Raspberry Pi Product Change Notification

RPI-POE-001

Revision change from PoE HAT revision 1 (R1) to PoE HAT revision 2 (R2)

Raspberry Pi PoE HAT

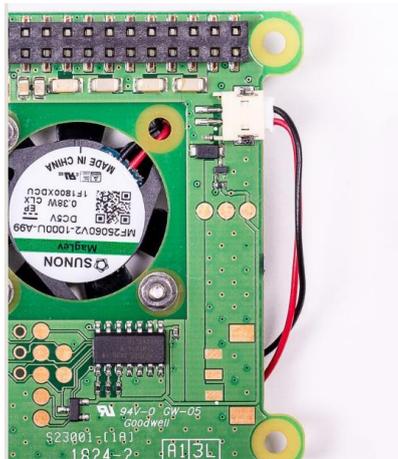
Problems have been reported with the initial PoE HAT board which, when powering certain Raspberry Pi units via the PoE HAT, it was not possible to draw the full rated current from the USB ports

Add L-C filter to apply further smoothing to the HAT output.

New L-C filter fitted to main PoE HAT PCB via the addition of a small mezzanine board as shown in the image below.

Original board (R1)

Modified board with mezzanine (R2)
